Extending B3 frame formats to include WDS support.

Revision 1.0

IEEE 802.11 Presentation Nov 1994 Page 1 DOC 84248 rev 1.0

Station States

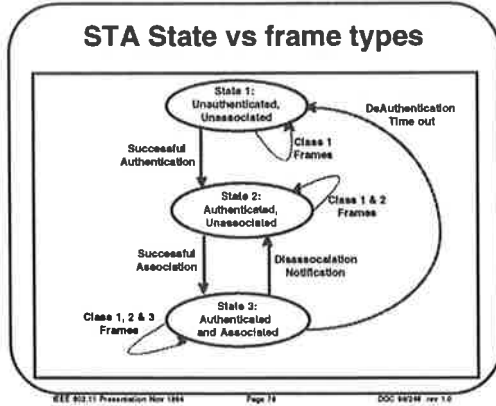
B3 Section 2 State Diagram Corrections

- Now that we understand the mixed mode cases it becomes clear that the transmitting station state diagram in sec 2.5 is incorrect and needs to be corrected.
- The existing states described in B3 section 2 are still correct, but the division of services is not.
- The correct dependency on STA state is sets of allowable transmit frames, not services.
- Any frame can be received at any time, but if not in a correct state at the receiver (e.g authenticated), an error occurs.

- State 1:
 - Initial start state, Unauthenticated, Unassociated.
- State 2:
 - Authenticated, not Associated
- State 3:
 - Authenticated and Associated.
